PHILADELPHIA ELECTRIC COMPANY

IE Bulletin 80-11

APPENDIX A

Peach Bottom Atomic Power Station

Figure 1 Energy Balance Technique

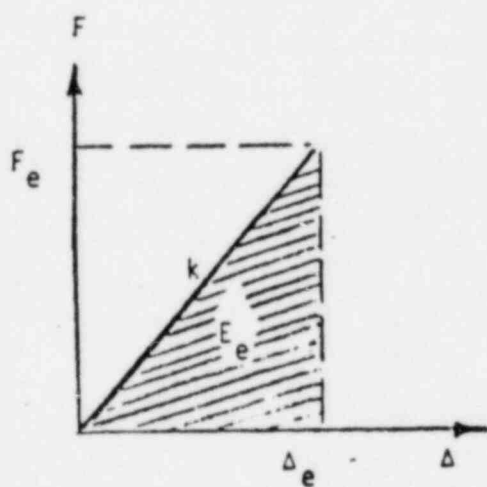
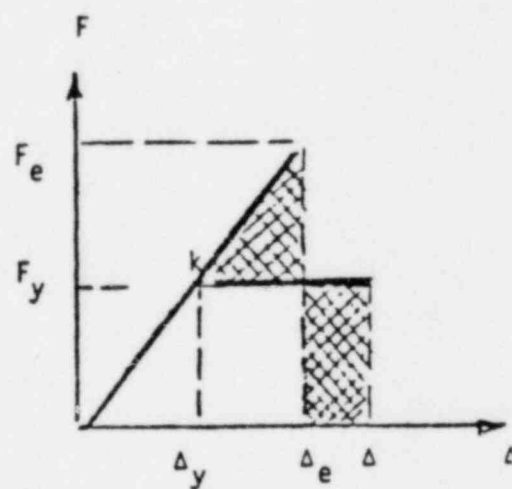
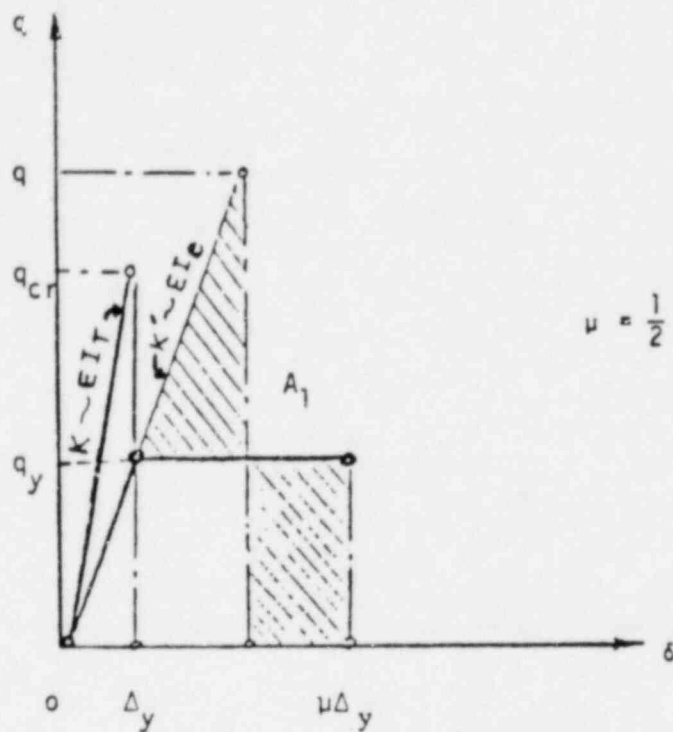
Justify the use of alternative acceptance criteria of Section 6.0, Appendix I, part 1, since it is the NRC's position that energy balance techniques and the arching theory should not be used in the absence of conclusive evidence of their applicability to masonry structures in nuclear power plants.

As mentioned in the response to question No. 14, 5 walls out of a total of 86 were qualified under the alternative acceptance criteria using the energy balance technique: the arching theory was not used to qualify any of the walls. It should be noted that all category I masonry walls at Peach Bottom are non-bearing and are not part of the lateral load

Reinforced masonry walls (a) that are not relied upon to provide strength of the structure as a whole, i.e., not acting as shear or bearing walls, and (b) that have sufficient capabilities to preclude brittle shear and anchorage failures, can undergo large ductile out-of-plane inelastic flexural deformations when subjected to the out-of-plane seismic inertia loading. Tests as reported in Reference 10 have indicated that regularly reinforced masonry walls are capable of developing ductile inelastic flexural deformations well beyond the cracking and yielding limits of the masonry wall subjected to out-of-plane uniform loadings. Tests in Reference 11 indicate that ductilities (defined as the ratio of maximum displacement of a single-degree-of-freedom elasto-plastic system to its yielding displacement) in excess of 25 are achievable when flexure is the dominant action. Other tests such as those reported in Reference 12 show that even when compression failures occur, ductilities in excess of 5 can be achieved. A more recent test program carried out by the Task Committee on Slender Walls of the Structural Engineer Association of Southern California (SEAOSC) in 1981 (Reference 13) has clearly indicated the capability of reinforced masonry walls in developing large ductile inelastic flexural deformations when subjected to out-of plane uniform loads.

It is, therefore, reasonable to allow inelastic flexural deformation with ductility of up to 5 for walls subjected to out-of-plane seismic loadings, as long as brittle failures are precluded and the safety systems on or adjacent to the wall are not jeopardized. For added conservatism, the maximum ductility allowed in the qualification of the five masonry walls at Peach Bottom was limited to only 3: the actual ductilities of the walls were well below this limit.

The "energy balance technique" utilized in analyzing the out-of-plane response of reinforced masonry walls subjected to seismic inertia load is, in essence, analogous to Newmark's inelastic seismic response spectrum technique (Reference 15) or Blume's reserve energy technique (Reference 14). This can be demonstrated by the seismic response of a single-degree-of-freedom (SDOF) system as shown in Figure 1(a). If this SDOF system is a linear elastic system, the maximum absolute acceleration response of the system subjected to a seismic input motion can be determined from the input motion acceleration response spectral value S_a at the system frequency ω and modal damping ratio β , i.e., $S_a(\omega, \beta)$. Since the damping ratio β is usually small, the maximum elastic displacement (Δ_e) and the maximum elastic force (F_e) induced by the seismic response can be determined by:

If the elastic spring of the same SDOF system is an elasto-(perfectly)-plastic spring having a yielding force at F_y and yielding displacement at Δ_y the maximum response of the system subjected to the same seismic input motion can be determined approximately based on the "energy balance technique" which assumes that the maximum energy (E_p) attained in the elasto-plastic spring is equal to the maximum elastic energy attained as if the system is elastic, i.e., $E_p = E_e$. Referring to Figure 1(c), this energy balance can be expressed as:

FIGURE No 1

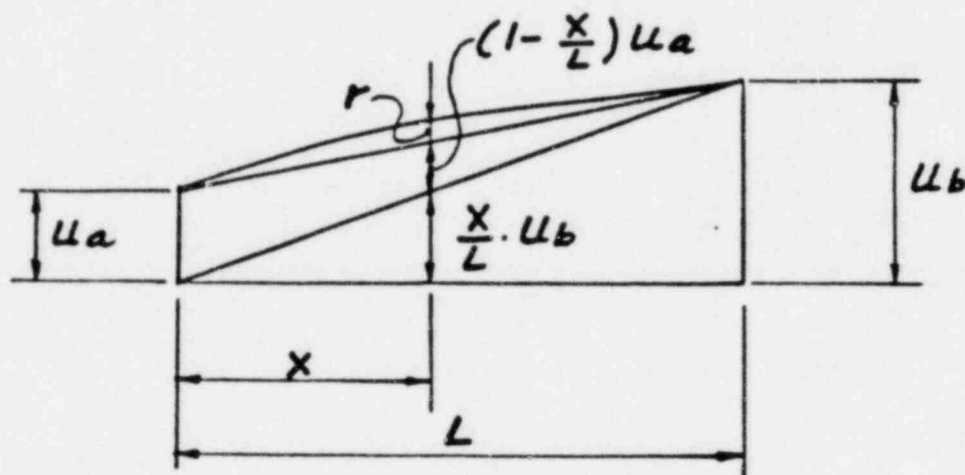
With reference to Section 7.1.2, Appendix I, part 1 [4], provide sample calculations to indicate how the effects of higher modes of vibration are accounted for.

With reference to Section 7.1.4, Appendix I, part 1 [4], justify the use of average floor acceleration instead of the envelope of the floor response spectra.

The evaluations herein demonstrate that: (1) The use of the average floor acceleration response spectra instead of the envelope of the floor response spectra for calculating the response of the wall panel is appropriate (response to question no. 8), and (2) The effects of higher modes of vibration are accounted for when uniform inertia load, based on the averaged floor spectral acceleration for the fundamental mode, is used in calculating the maximum seismic response of the wall (response to question no. 7).

For the purpose of this evaluation, the seismic response of a simply-supported, uniform beam simulating a strip of the wall panel with unit width is considered, as shown in Figure 1.

where L is the length of the beam. The relation expressed by the above equation is shown in Figure 2. The relative displacement $r(x, t)$ needs to satisfy the following simply-supported conditions:

MOMENT - ASPECT RATIO CURVE

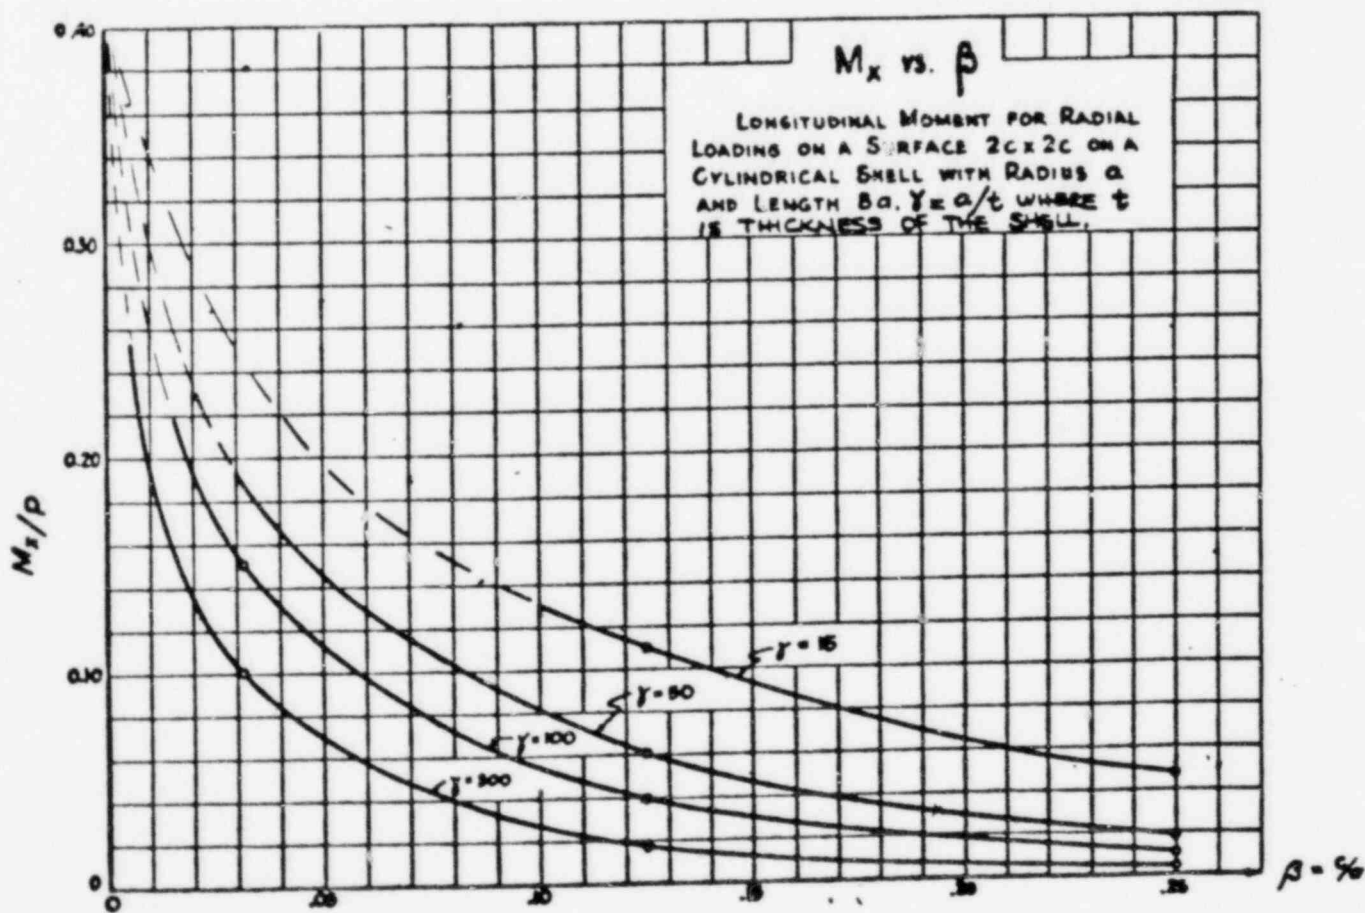
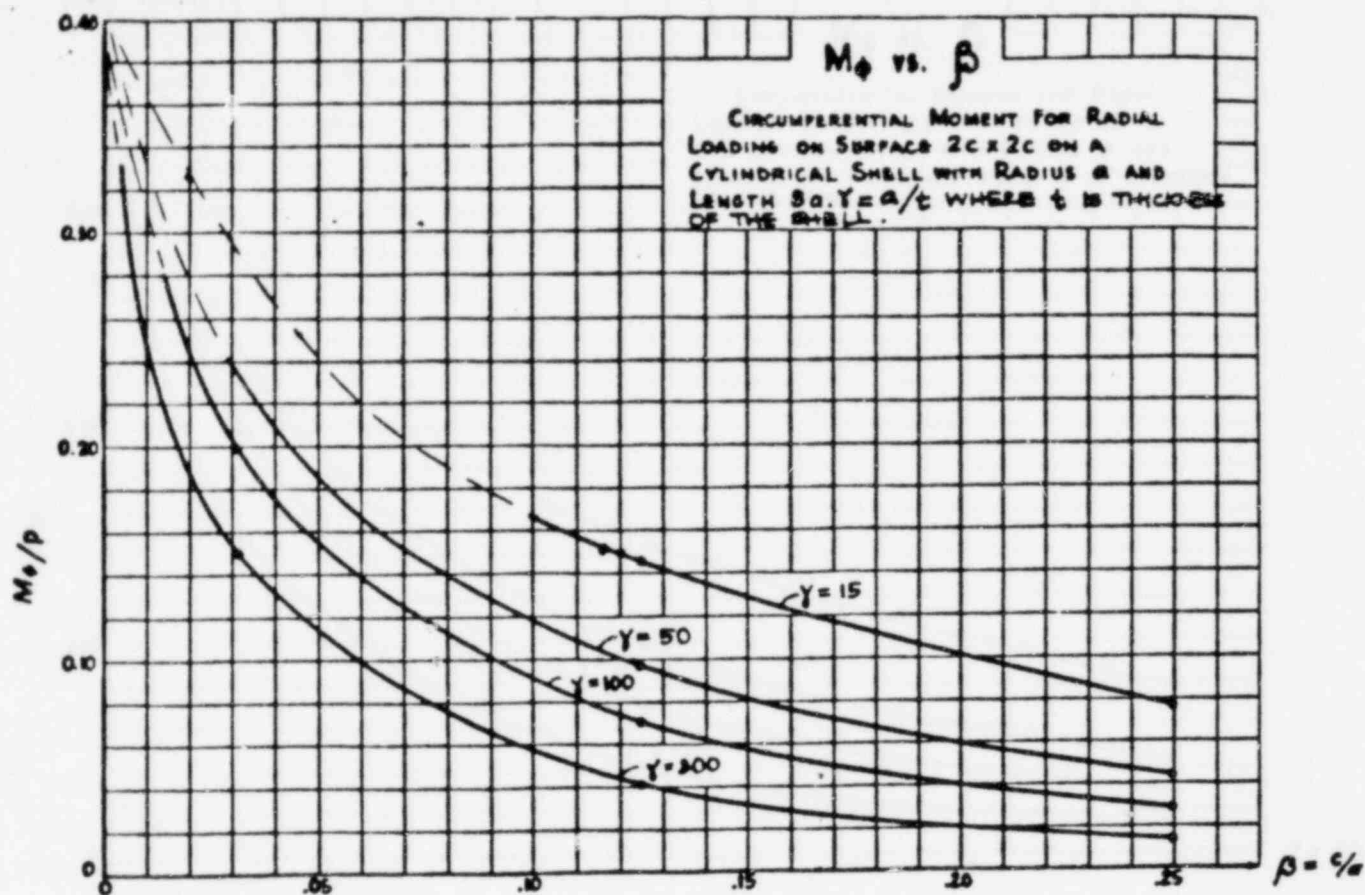
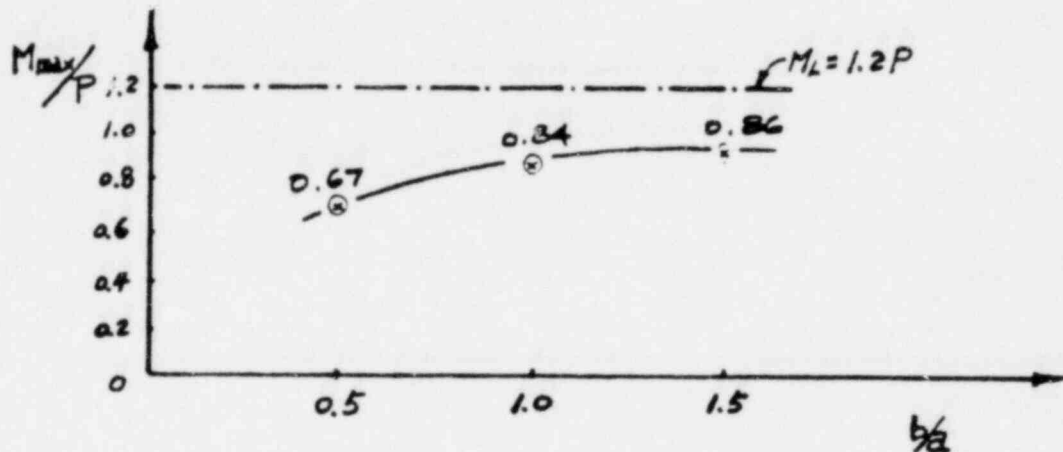
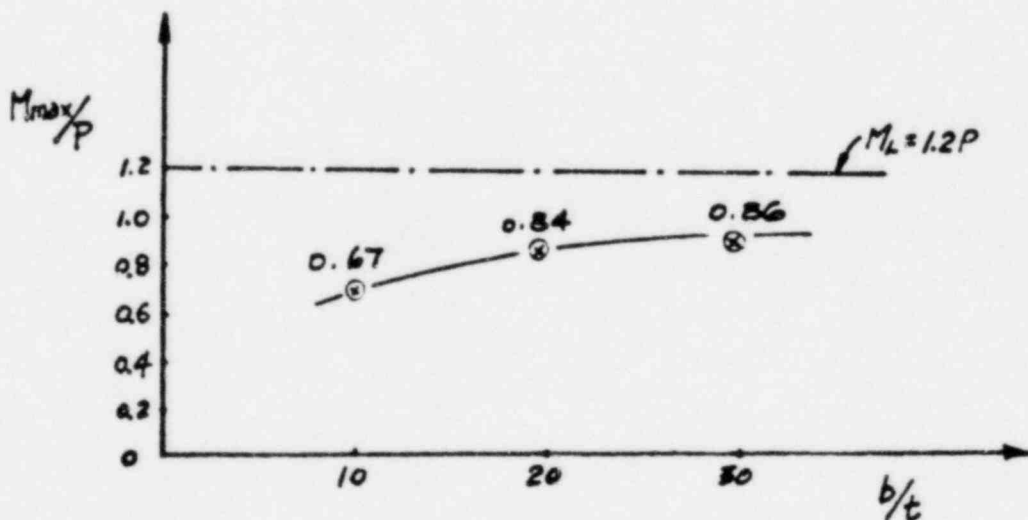
With reference to Section 7.2, Appendix I, part 2 [4], provide justification and references for the formulae used to determine moments. Indicate how the walls with openings were analyzed.

The formula referred to in the question give upperbound values for moments in a plate due to concentrated loads. These formulae were not used in the re-evaluation of masonry walls at Peach Bottom. Instead, as mentioned in the response to Question No. 10, computer programs were used to analyze the walls accurately when concentrated loads were present and/or the walls had significant openings.

- (3) Sheet No.27 is taken from Ref. 21 and it shows that as β approaches zero, i.e. in the case of plates, for all values of γ , $M/P = 0.4$ or,

Equations (1) through (4) illustrate that a conservative estimate of the maximum localized moment per unit length for plates supported on all sides and subjected to a concentrated load P can be taken as:

PLAN OF WALLS REQUIRING SUPPORT
MODIFICATION (4 WALLS)
(N.T.S.)

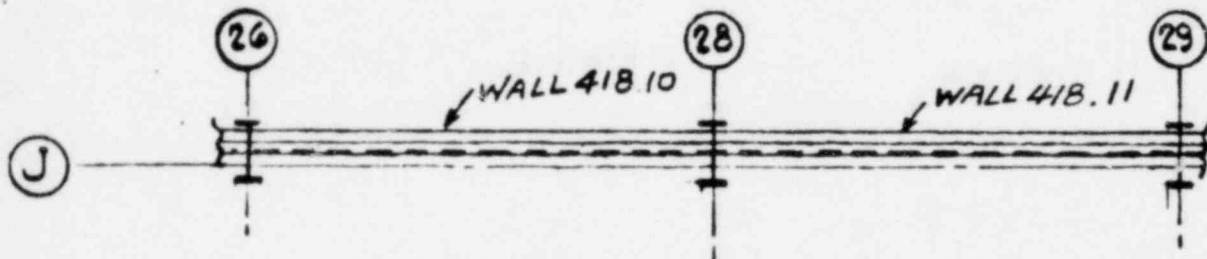
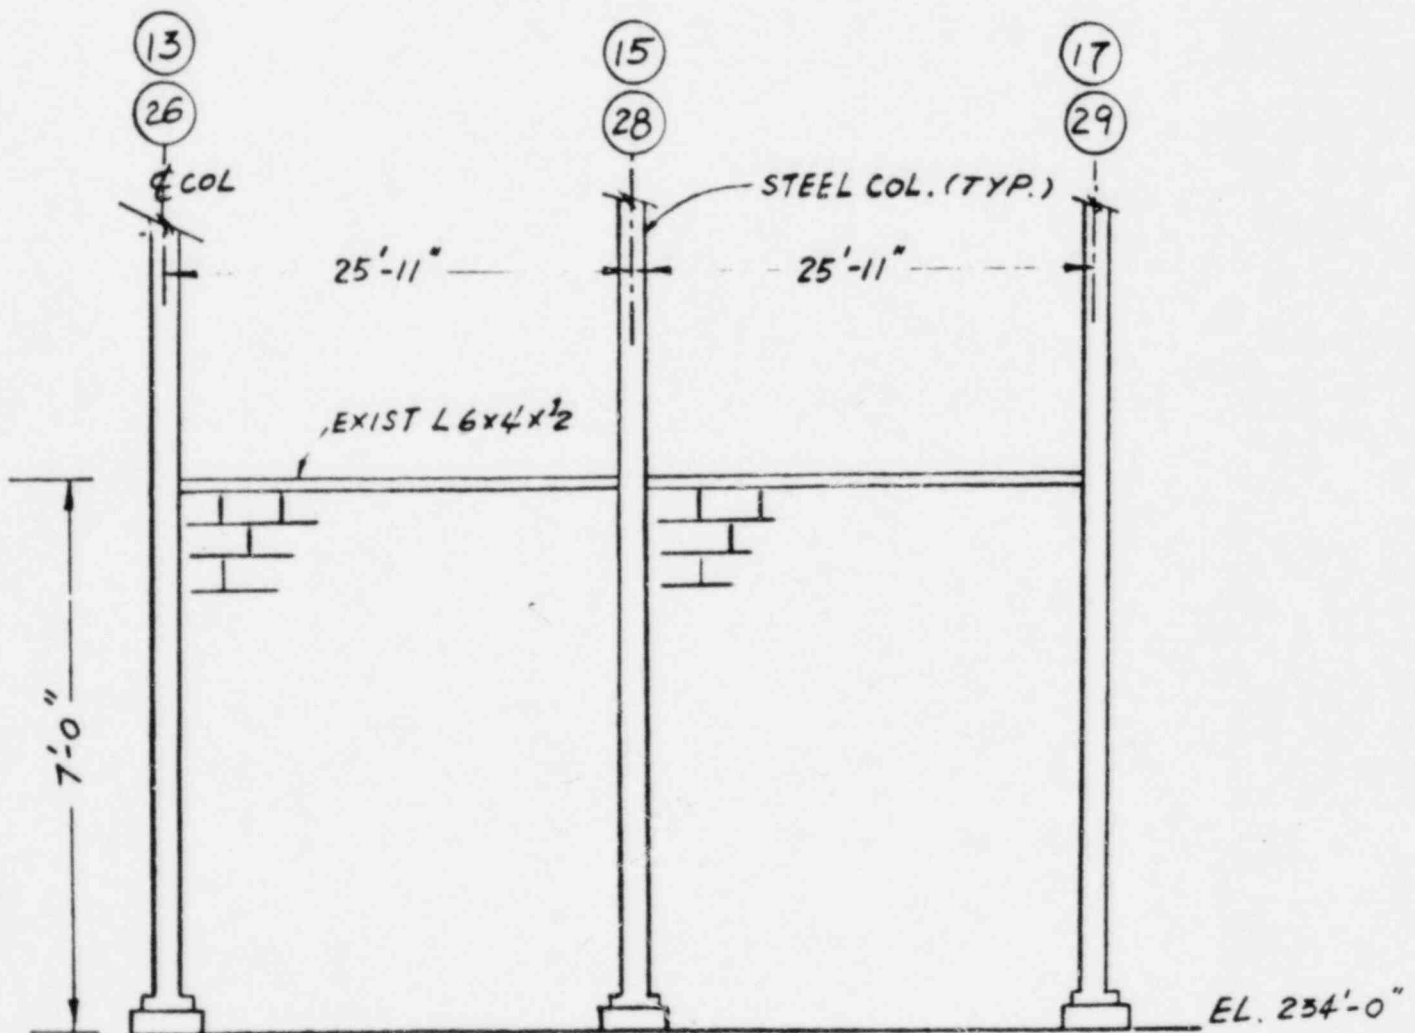
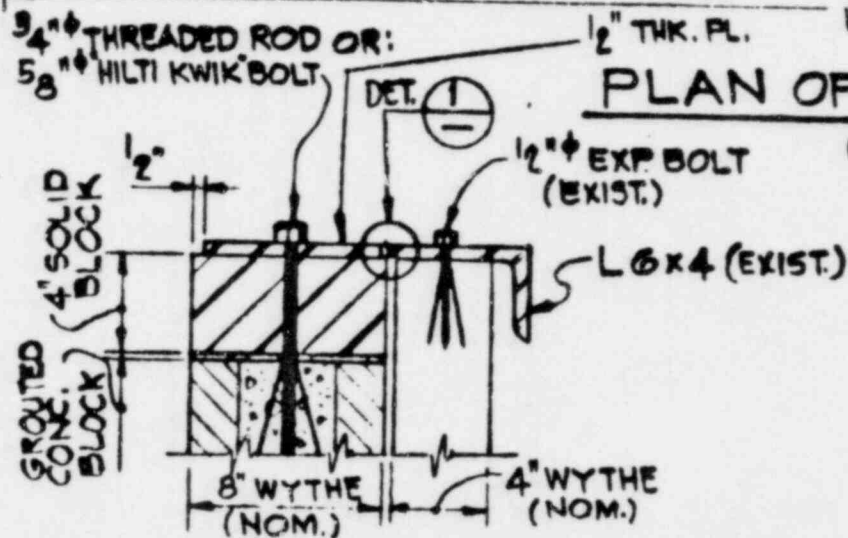
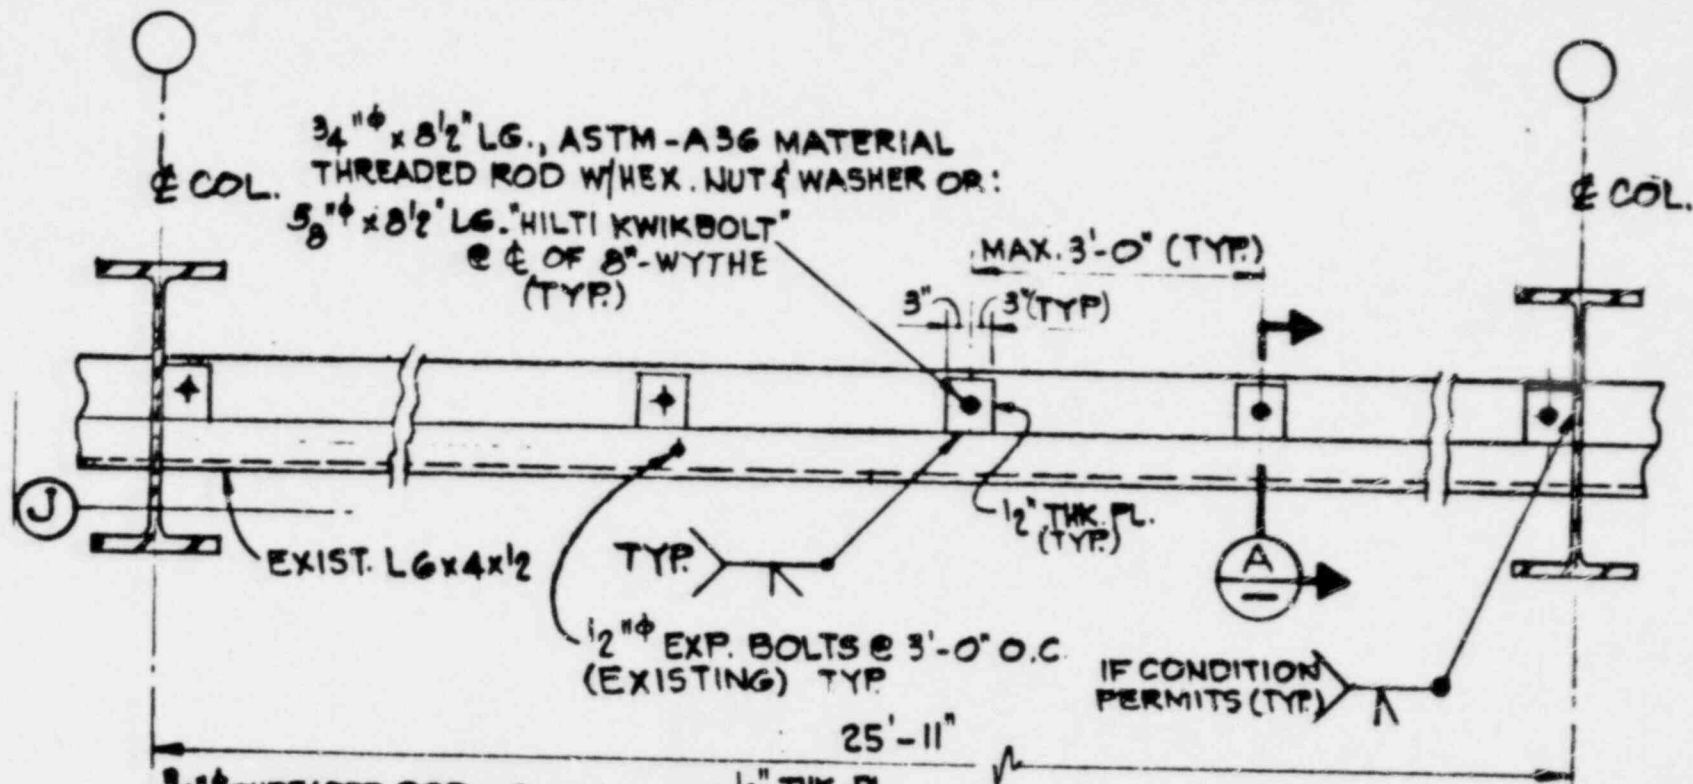
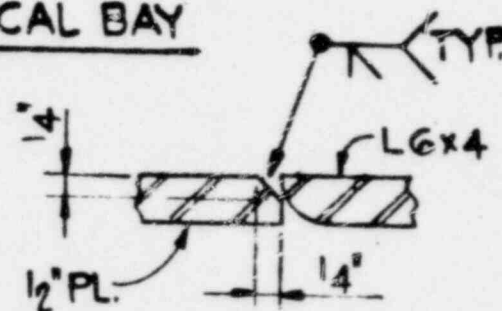
Provide details of proposed wall modifications and indicate, using sample calculations, how these modifications will correct the wall deficiencies.

The details of the wall modifications for walls 102.8, 102.9 418.10 and 418.11 are shown on sh. 52 and 53.
32 33.

These walls have a simple support at the bottom and their vertical sides are free, except at the corners where 6x4, continuous along the top edge of each wall, is welded to the column webs. Prior to the modification, 6x4 was anchored in the 4 in. wythe by means of 1/2 in. diameter expansion bolts and had no connection with the 8 in. wythe. In the re-evaluation of masonry walls a conservative assumption was made that collar joints had zero shear strength. Theoretically, this meant that, except under bearing conditions, the

angle on the 4 in. wythe provided no support to the 8 in. wythe. To perform a meaningful analysis, consistent with the assumption of zero collar joint strength, it was necessary to make the angle support at the top effective for the 8 in. wythe. Modifications to the wall were, therefore, made to improve the support conditions at the top edges.

As shown in the modification details, the 1/2 in. thick plate is anchored in the 8 in. wythe with 5/8 in. diameter expansion bolts. Since this plate is also welded to $\angle 6 \times 4$, the two wythes are now connected at the top and the angle on the 4 in. wythe provides the necessary support for the 8 in. wythe. An analysis performed on the modified wall indicated that the stresses and deflections, both in the wall as well as the angle, were well within allowable limits under all applicable loading conditions.
